# Television

Chassis

ITC008

## TECHNICAL INFORMATION N°2003 - 38

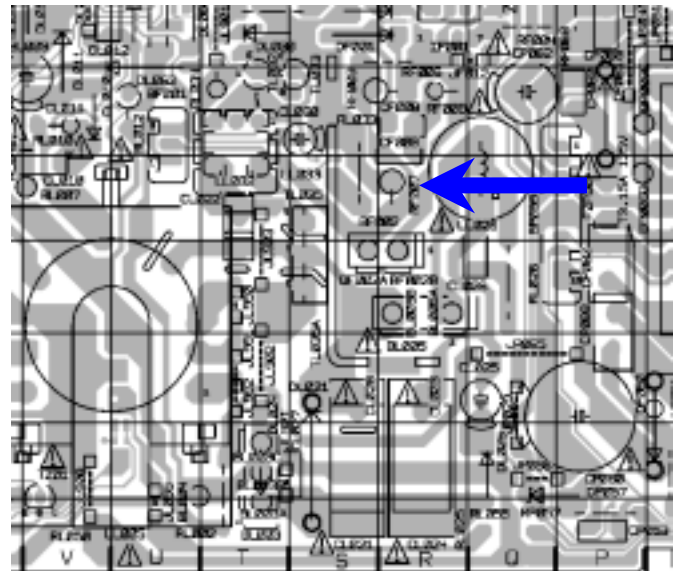
Horizontal line rolling down the screen from the top to bottom.

- Change resistor at location RF007 from a 1.21Ω to 1Ω 1% 0.700W (**PART No 10254220**).
- Remove the resistor at location RL130 (EWM Board).

## TECHNICAL INFORMATION N°2003 - 54

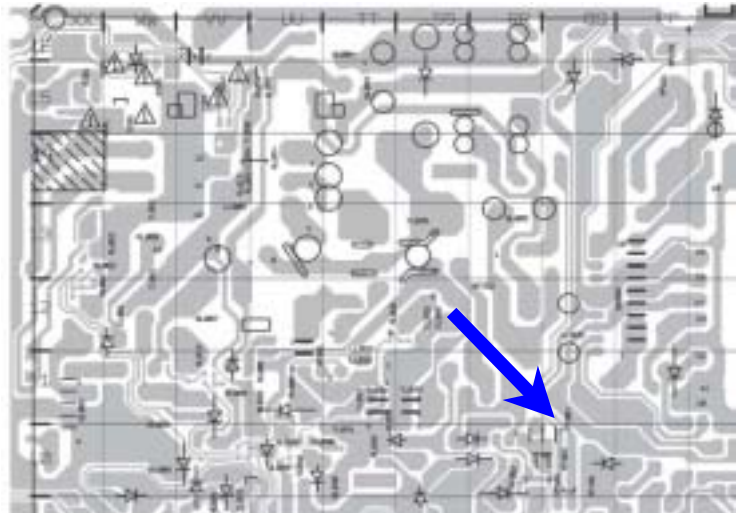
**Symptom / Problem observed :**  
A vertical jitter appears after a certain time or immediately after the switch on.

**Cause :**  
The capacitor CF004 is defective.

**Solution :**  
- Replace CF004 capacitor by another of the same value (1nF 50V) **PART No 10138550**.

## TECHNICAL INFORMATION N°2003 - 47

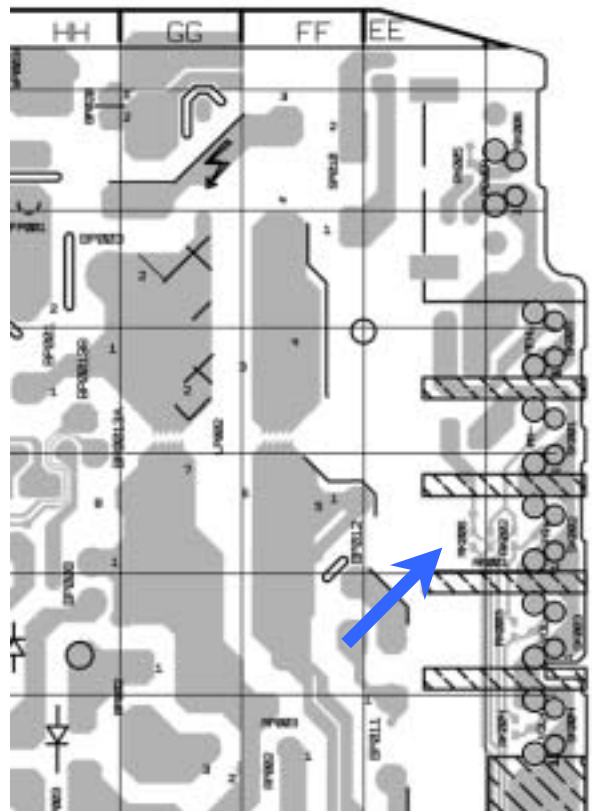
After 2 or 3 working hours, the set switch OFF and switch ON again without apparent reason.  
(The symptom is repeated every 45 minutes)

Remove the resistor in position RK006.
